The Greater Cambridge Design Review Panel

Pre-application ref: PPA/24/0044

Kett House, Cambridge

Thursday 14 August 2025, In-person meeting

CGI – Station Road extracted from Kett building DRP presentation (August 2025)

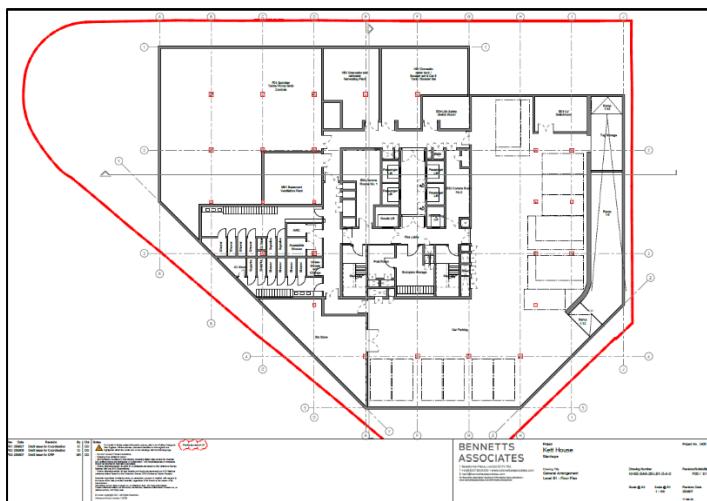
The panel member specialist is concerned that the planting on the colonnade seems bolt on, superficial, out of character and scale with what's happening elsewhere on the building. She suggested omitting this planting and explore other forms of decoration of the colonnade. Could the applicant consider bringing in some texture and detail on the columns, whether it is something very simple or sculptural signage. The CGIs showed planters put up against the colonnade in a different material.

For this space in Station Road, is it read as a single space that is totally open or do you recognize that actually most people walk either side of the columns so that planters could extend between the columns and help define these two routes. It could be worthwhile doing something different with the linear route in the covered space. The applicant needs to be strong and definite in their landscape provision. At the moment, this area does not have the strength and clarity of the other landscaped areas.

For the CGI of colonnades on Station Road, (on page 27 of the presentation), the appearance is not convincing. The planting on the columns seems weak. The use of art or colour or more texture on the columns could help the colonnade become more “civic” or more “massive” In the same image, there is not much stone left in-between the windows and so it might not be experienced as the “base” material for the building. If the windows get narrower in response to overheating, it will have the merit of presenting more of the stone material. Overall, he is pleased with the massing but there could be further improvements to the detailing to create more variety in the facades.
